John Otterbein Environmental Specialist

Northern Environmental Solutions

The applicant is requesting relief from St. Louis County SSTS Ordinance 61 adopted Technical Standards 7080.2150, Subpart 2 (F),

Variance Request

Applicant Site Sketch

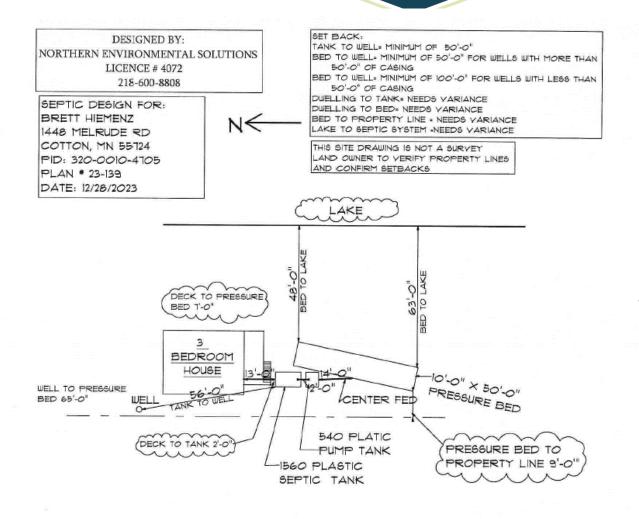
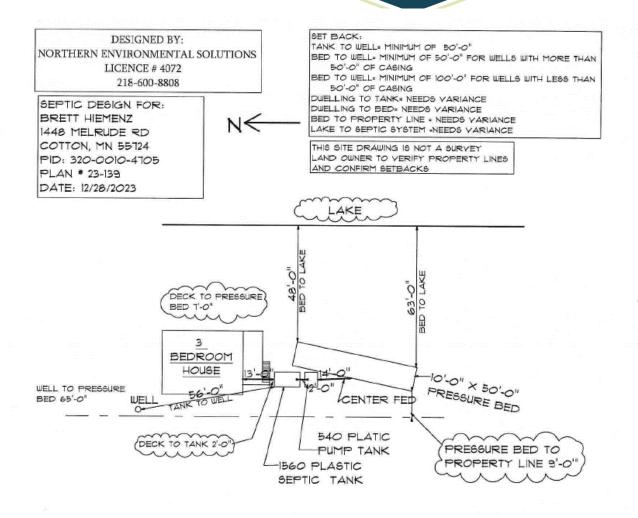
- The applicant is requesting to replace a subsurface sewage treatment system at a reduced shoreline setback of 48 feet where 75 feet is required.
- To replace a subsurface sewage treatment system at a reduced property line setback of nine feet where 10 feet is required.
- To replace a subsurface sewage treatment system at a reduced structure setback of two feet where 10 feet is required.
- This system is a replacement to abandon an existing failing system.

- 1. Ordinance 61 states that all SSTS components must be setback in accordance with Table VII of the SSTS Technical standards.
- The required shoreline setback on a Recreational Development lake is 75 feet. The applicant is requesting a reduced shoreline setback of 48 feet.
- 3. The required property line setback is 10 feet. The applicant is requesting a reduced property line setback of nine feet.
- 4. The required setback from an existing structure is 10 feet. The applicant is requesting a reduced structure setback of two feet.

- 1. The parcel is zoned Shoreland Multiple Use 7. The lot is 0.60 acres and 88 feet wide where 1.0 acre and 150 feet lot width is required.
- 2. There is minimal conforming area for replacement, due to the parcel's narrow width and acreage.
- 3. The parcel contains a drilled well which requires a 50 foot setback, which limits replacement area for the system.

- 1. All other Onsite Wastewater SSTS standards shall be met.
- Following system installation, an inspection shall be performed by a qualified inspector to ensure setbacks are met prior to issuing Certificate of Compliance.
- 3. All other local, county, state and federal regulations shall be met.
